OFFICIAL MINUTES
SUMMERSET PLANNING AND ZONING COMMISSION
REGULAR MEETING
TUESDAY, NOVEMBER 12th, 2024 @ 6:00 P.M.

**REQUEST FOR EXCEPTION TO
SUMMERSET DESIGN STANDARD / CRITERIA / REGULATIONS**

PROJECT Norman Ranch Subdivision Phase 1A & 1B

Norman Ranch Design Exception Request (11-01-24)

Norman Ranch Utility Report (11-01-24)

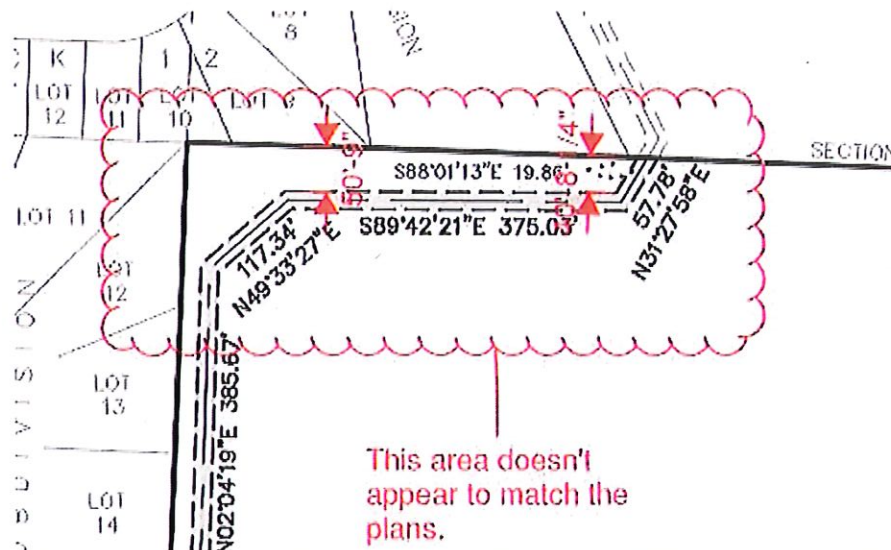
10. A meeting took place where HDR suggested addressing a list of items associated with a lift station design. Items that were requested to be addressed but are either absent or lacking detail:
 - a. Odor control
 - b. Data for all proposed valves (check, isolation, air and vacuum)
 - c. Inclusion of a flow meter
 - d. Noise control
 - e. Power plan
 - f. Instrumentation and Controls (pump control logic, proposed instruments, plc inputs, alarms/communication)
 - g. Design FM to convey a pig (pig launch added at lift station but its unclear if valves are full port).
 - h. The proposed air release valve is for water and not appropriate for wastewater service. The valve is air release only, combination valves are anticipated to be required is some locations.

Norman Ranch Phase 1A Plans (9-25-24)

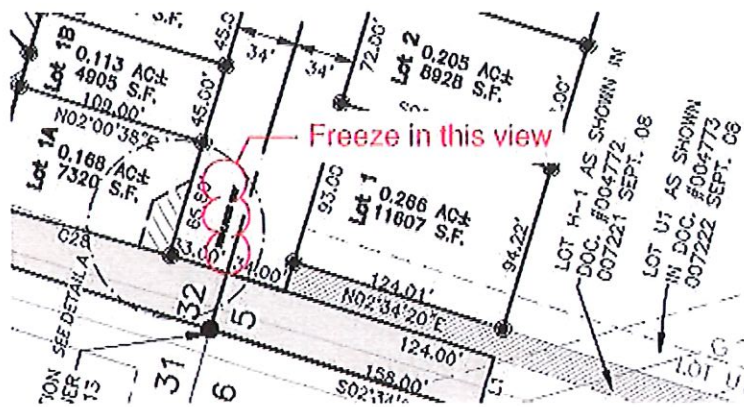
20. Will need USACE jurisdiction determination/approval prior to 15" storm culvert and riprap from the pond, the 72" culverts and riprap and gravel road installation work in existing drainage.
